Observations regarding
Draft Implementation of the Turbidity Criterion for the
Protection of Coral Reef and Hardbottom Communities
(FDEP, September 2019 – draft)

Kevin R. Bodge, Ph.D., P.E.
Olsen Associates, Inc.
31 October 2019

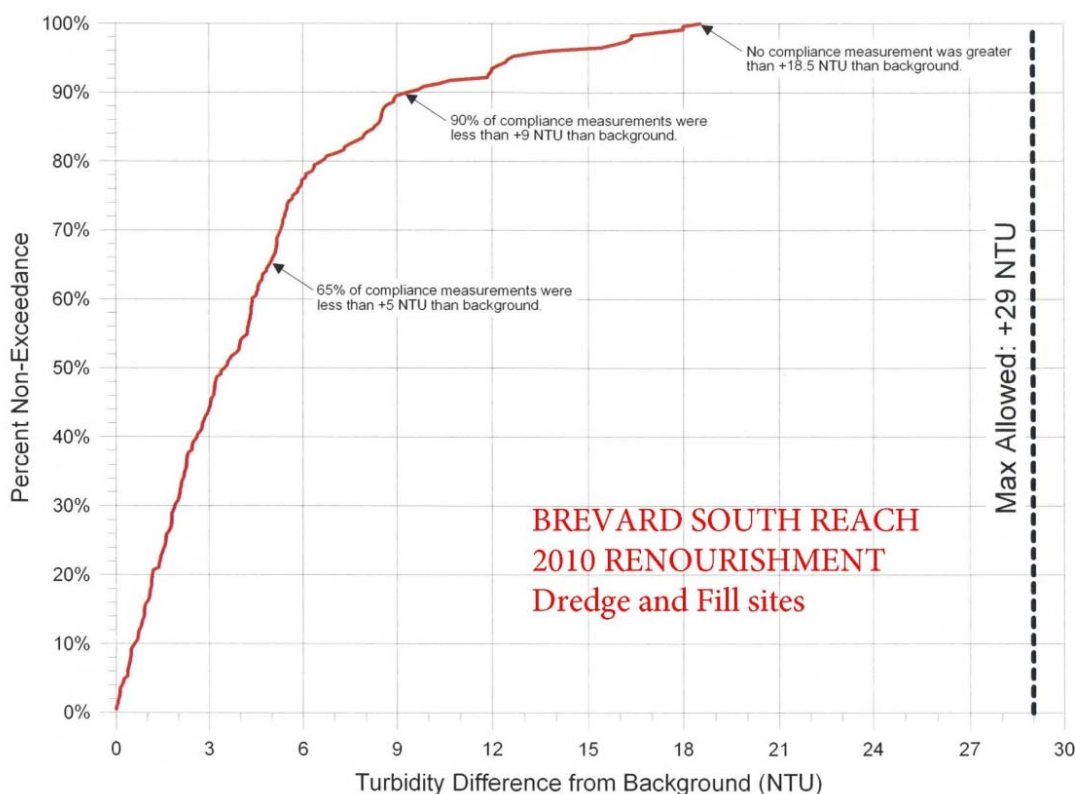
“If multiple community types are present within the project area, multiple baseline stations may be needed to address the different background conditions”. This may require twice as many field days, since the maximum likely number of stations that can be measured in a given field day is three. For projects requiring more than 3 stations:

Total cost per event would thus be closer to: \$67,000

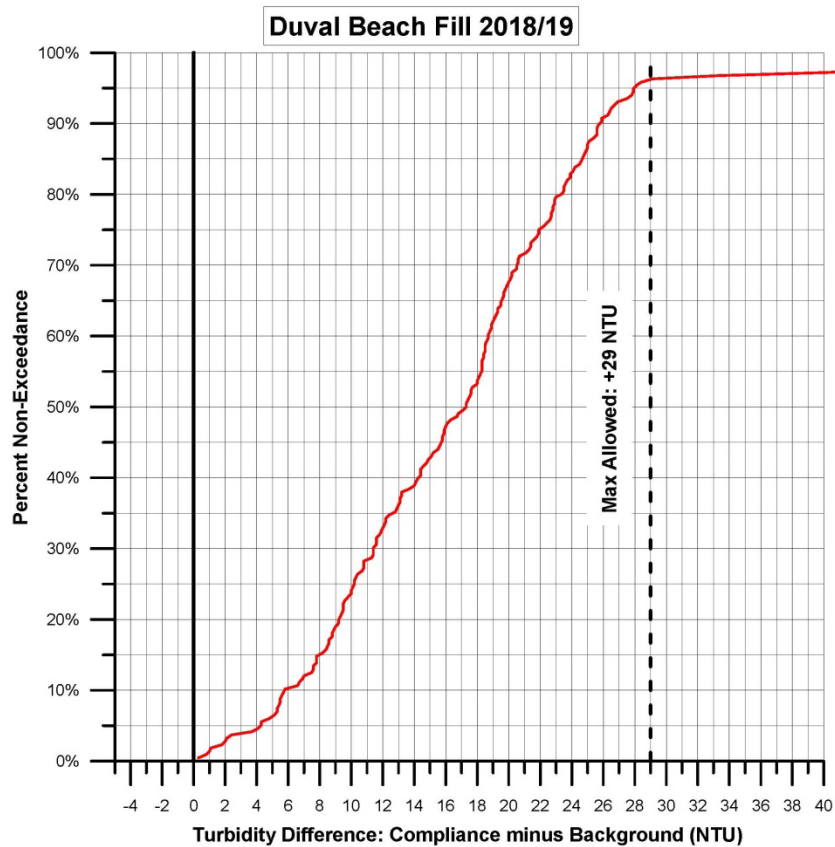
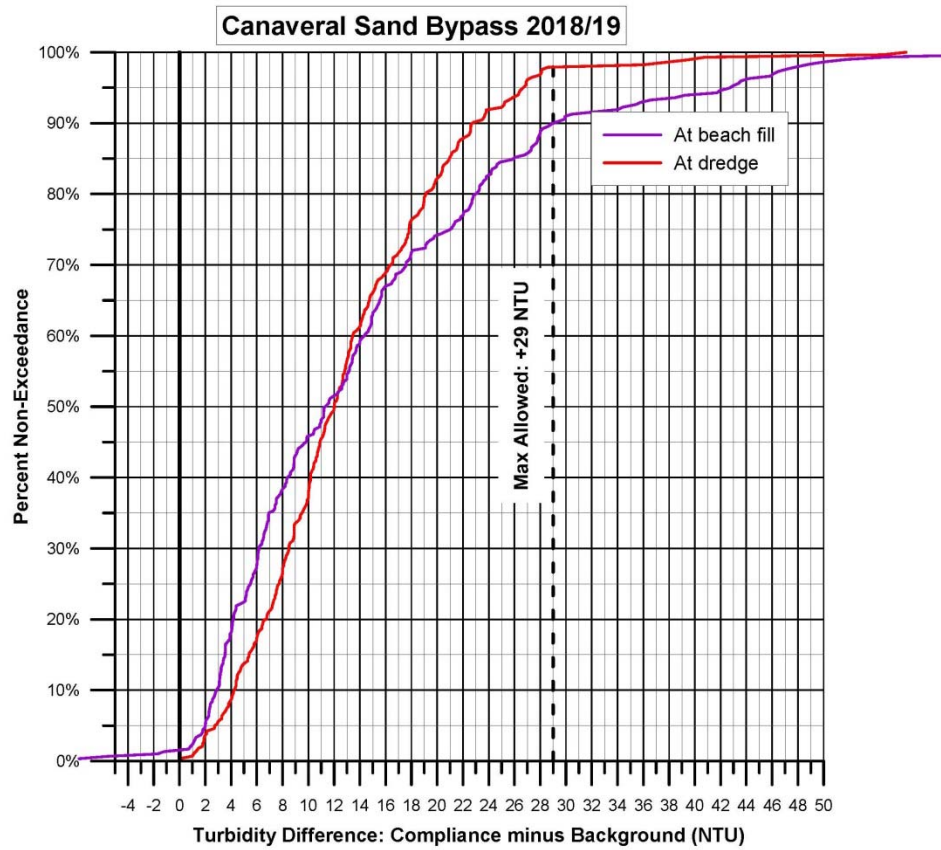
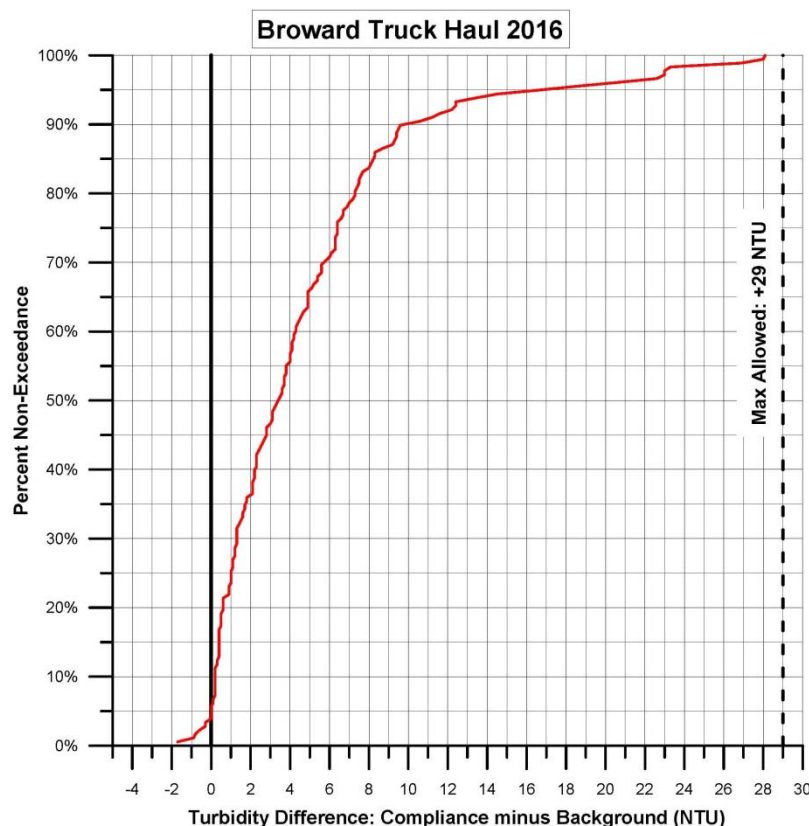
15. The following graphs depict the occurrence of actual measured turbidity levels (compliance value minus background value) during the construction of four different types of beach nourishment projects along the central-southeast Florida coast. Each project includes “high-quality” beach fill sand that exhibit minimal amounts of fine sediment (<2% at most). These projects include:

16. Each graph depicts the cumulative occurrence (non-exceedance) of turbidity compliance levels for all data collected during each project. For example, from the first graph, below, 90% of all turbidity measurements collected at both the dredge and beach fill sites for the Brevard County South Reach renourishment in 2010 exhibited compliance values that were less than 9 NTU above background. Conversely, 10% presented values that were greater than 9 NTU above background.

17. These graphs provide an indication of actual prototype levels of compliance turbidity (occurrence of construction-minus-background turbidity) that have been observed at four recent, typical projects that include hopper-dredge placement from offshore sources, cutter-head bypass from a natural beach, and truck-haul placement from a high-quality upland source. These are four more or less randomly selected projects, spanning a variety of very “clean” beach fill sources, for which data was readily available for plotting.
